UNITED STATES PATENT AND TRADEMARK OFFICE  
**CERTIFICATE OF CORRECTION**

PATENT NO. : 7,060,017 B2  
APPLICATION NO. : 10/821562  
DATED : June 13, 2006  
INVENTOR(S) : Kevin E. Collier

FIG. 5

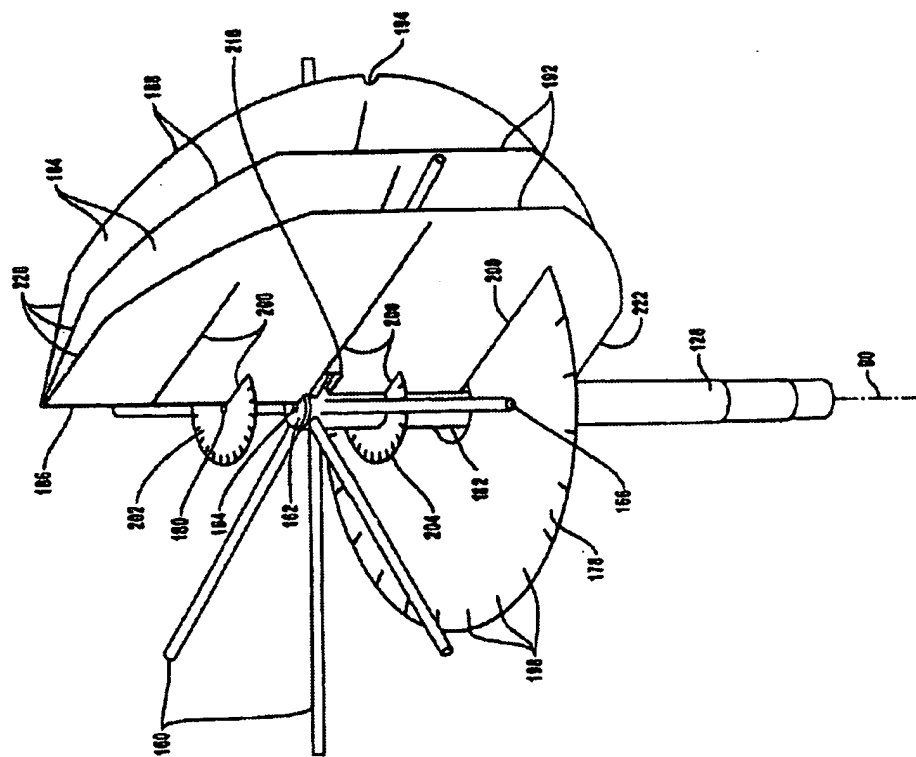
Sheet 4, replace Figure 5, with the figure depicted herein below, wherein the "central orifice" of "disk 178" has been labeled with --182--

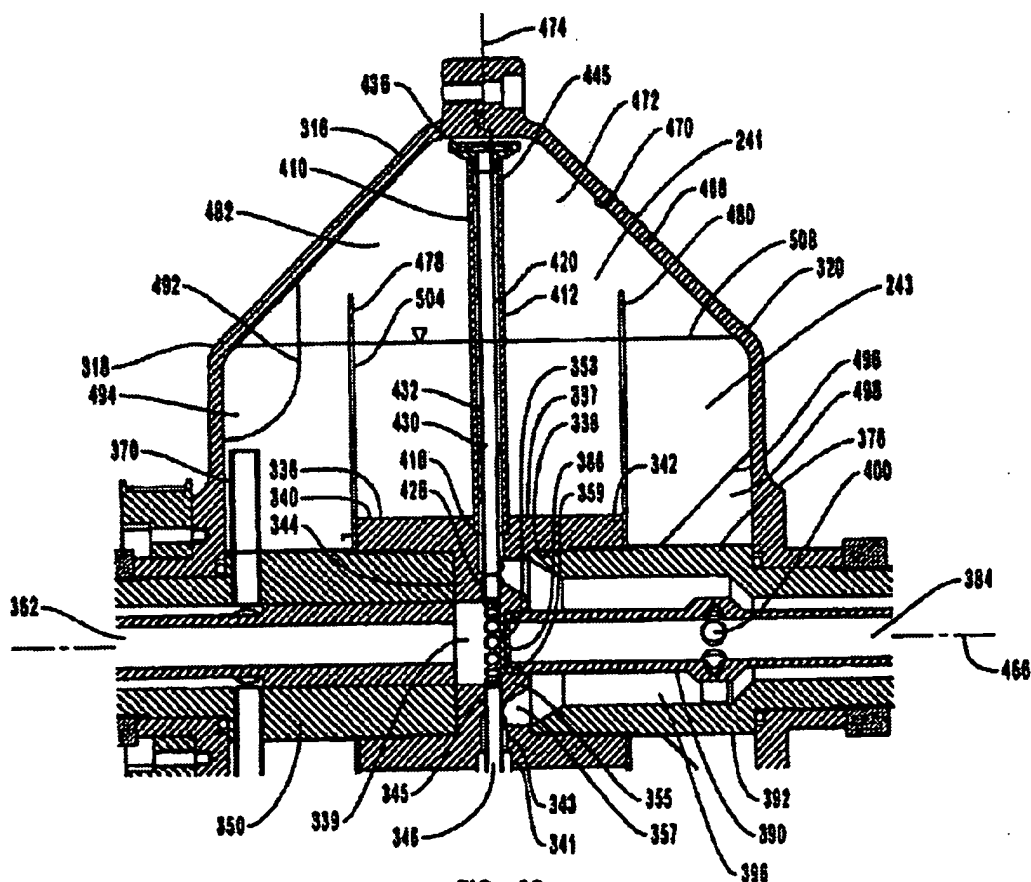
Sheet 21, replace Figure 22 with the figure depicted herein below, wherein the "nozzle" has been labeled with --436--

FIG. 24

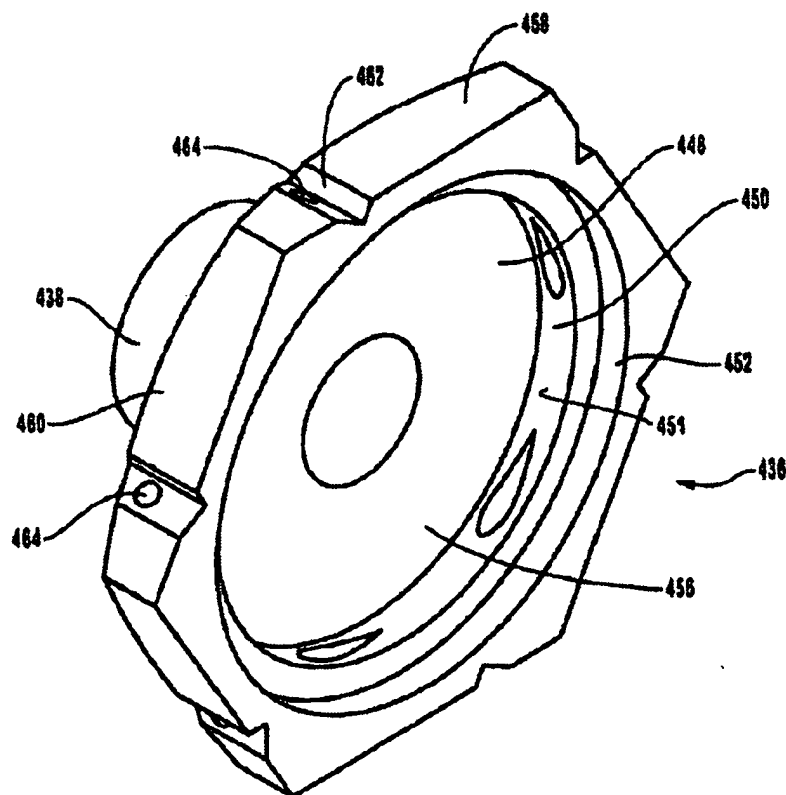
Sheet 23, replace Figure 24 with the figure depicted herein below, wherein the "interior surface" of "sidewall 450" has been labeled with --451--
